CITY OF CODY
PLANNING, ZONING AND ADJUSTMENT BOARD
TUESDAY, OCTOBER 13, 2020
CITY HALL COUNCIL CHAMBERS @ 12:00 NOON

MEETING DATE:	OCTOBER 13, 2020	TYPE OF ACTION NEEDED	
AGENDA ITEM:		P&Z BOARD APPROVAL:	
SUBJECT:	PRELIMINARY PLAT FOR A 4-LOT MINOR SUBDIVISION BY JCA, LLC SUB 2020-06	RECOMMENDATION TO COUNCIL:	X
PREPARED BY:	TODD STOWELL, CITY PLANNER	DISCUSSION ONLY:

**PRELIMINARY PLAT
SHEET 2: SITE/UTILITY PLAN**

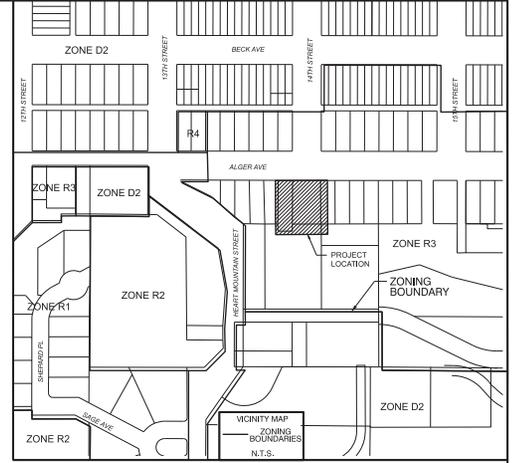
It is noted that maintaining minimum required cover over the waterlines must be considered. This applies not just for the water lines, but all utilities. The situation is such that there is a retaining wall behind the sidewalk, and the property to the south is higher (see contour lines on Sheet 2). When the driveways are installed, much of that will be cut down. The utilities must be deep enough that they still meet minimum cover requirements considering final finished grade. The reference to finished grade and utility depths is properly noted in Note 2 on Sheet 2. If existing utilities do not have sufficient cover below finished grade, they too will need to be lowered accordingly.

Comments: The plans are shown. Refer to "H" above for a discussion on minimum cover. There is a minor correction needed to the labeling in the NE corner (treated water line not going to correct tap, and new secondary power label not going to correct line). Also, the new secondary pedestal will need to be shifted slightly west, so that it does not block access to the 5-foot right-of-way along the east property line. Coordinate exact location of the pedestal with Public Works.

The gas services are shown, yet need coordinated with Black Hills energy. It is recommended that all new utility service lines be located outside of the curb cut/driveway areas where possible. Curb stops or sewer cleanouts in the driveway areas will need special protection.

Telecommunication services are not currently shown, but can be added once coordination occurs with those providers, as part of the final plat process.

1. Modify the utility plan where possible to remove new service lines from coming from the street into the curb cut/driveway areas. Add telecommunication (phone, cable, internet) lines. If applicable due to location, note the need to provide concrete collars on any sewer cleanouts and valve covers on the water curb stops, when located in the curb cut/driveway areas. Also make the minor edits to the labels at the NE corner of Lot 4.

2. The existing house and garage will need to be removed and any unused utility services abandoned per the utility provider requirements before the final plat is signed by the mayor.
3. The portion of the existing curb cut at the northeast corner of Lot 4 must be removed and replaced with standard curb and gutter and the east panel include the slope to the neighbor's driveway.
4. All work within the Alger Avenue right-of-way requires a street encroachment permit from Public Works, prior to excavation or construction.
5. Provide the final plat in accordance with the subdivision ordinance requirements. Also provide a clean copy of the final utility plan (Sheet 2).
